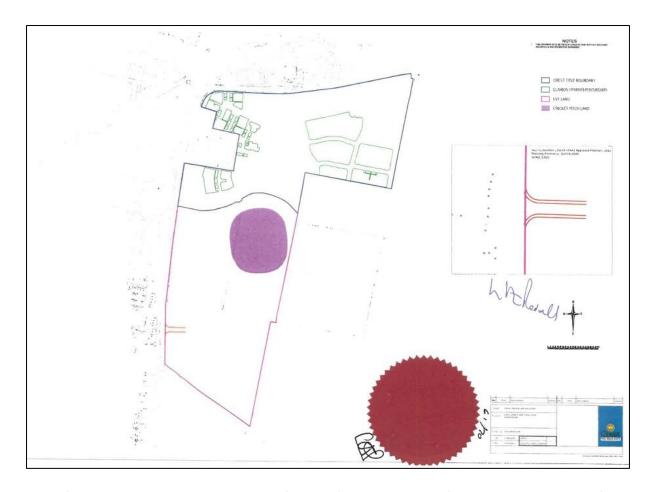
The applicants state in the DAS that the site is predominantly arable land. They are silent on the use of the subservient land. We have identified this use by overlaying the built footprint for the application site over the approved plan (to the `north) for the Crest Nicholson scheme (18/501408/REM). (Appendix 1)

It can be seen from the crosshatched lines that the subservient use approved is Public Open Space and Amenity land. This land is protected by the following policies in the Local Plan: -

Clause 9.3 in Schedule 1 of the S106 Agreement dated July 2020 also protects the position and states: -

'The Owners shall not dispose or transfer the Landscape Areas and Open Spaces without the consent of the Council other than (following completion of the Open Space Works) to the Council at nil value'. This clause is common in S106 agreements and is inserted by the council to secure the long-term stewardship and use of non-remunerative land.

The council would be breaching their duty of care to the community if they were to release the burden of this covenant to enable development on this land in the event the application is approved by the planning committee or at appeal. In the light of this the application is flawed and applicants may wish to consider amending the application to exclude the area of this public open space.

The updated s106 for the outline application (signed 3rd July 2020) is also clear where the Crest title boundary is and shows the open space / cricket pitch land excluded – see extract below.

As no further RM applications have come forward for this element of the site, this element of the Outline planning permission has since expired.

Notwithstanding this, proposed development under the current application will retain this space for open space and sports provision. The submitted masterplan shows the provision of football pitches on the site, which is based on the understood need – for example Faversham Strike Force have a sizeable waiting list to join – and further detail will be submitted as part of a future Reserved Matters application and Fernham Homes will liaise with the relevant stakeholders to deliver the required sports provision.
